Addendum 144 – UN Regulation No. 145

Amendment 4

01 series – Date of entry into force: 15 June 2024

**Uniform provisions concerning the approval of vehicles with regard to
ISOFIX anchorage systems ISOFIX top tether anchorages and i-Size
seating positions**

Article I. Figure 1
Lower Tether Anchorage Zone: Side View
(Dimensions in millimetres)

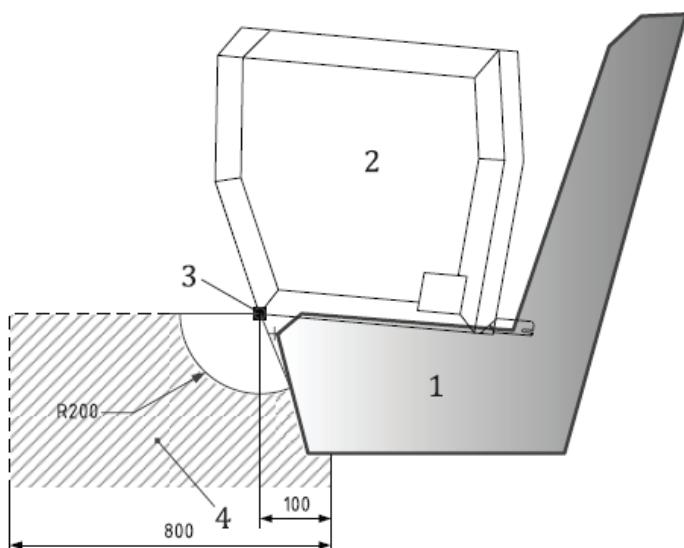
- 5.4.2. Number and Positioning
- 5.4.2.1. Each intended (E)CRS position may be provided with a single or two LTAs, located within the zones shown in figures 1 to 3 of Annex 6 and according to the following specifications.

Insert new Annex 6, to read:

- Key:*
1. vehicle seat illustration.
 2. ISO/R2 envelope installed in related vehicle seating position.
 3. reference point on ISO/R2 envelope for LTA zone measurements.
 4. lower tether anchorage zone in side view, with upper limitation.
 5. where the LTA is integrated with the seat in front, the zone requirements have to be fulfilled independent of the height adjustment settings of the seat in front, taking the presence of the ISO/R2 envelope into consideration.

Figure 3
Force Direction Reference Point and Direction of Test Force

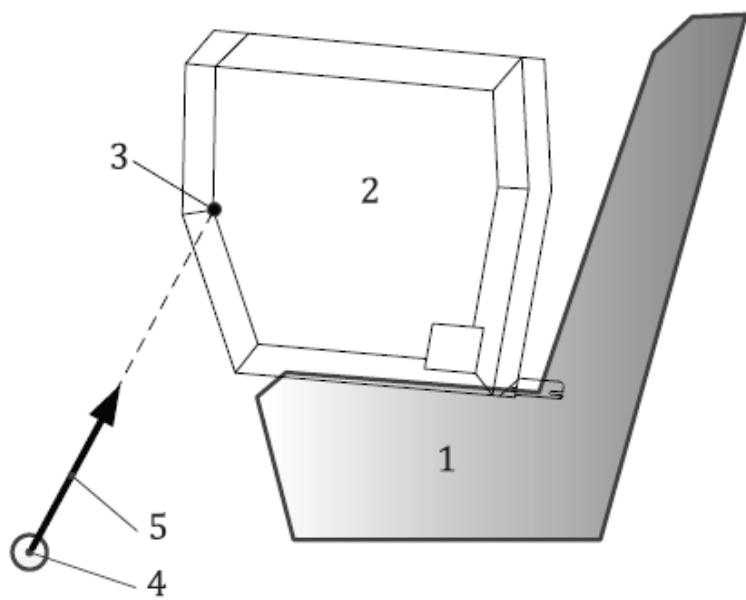
- 6.3.4. The force:
- 6.3.4.1. Shall be applied in a direction determined by the FDRP (force direction reference point), with a tolerance of $\pm 20\text{ mm}$ in all directions given in figure 3 of Annex 6, noting that the FDRP lateral position coincides with the centreline of the ISO/R2 envelope;

- Key:**
1. vehicle seat illustration.
 2. ISO/R2 envelope installed in related vehicle seating position.
 3. FDRP (force direction reference point).
 4. example of actual LTA position in vehicle.
 5. test force direction.

Note: The lateral position of FDRP coincides with the centreline of the ISO/R2 envelope"
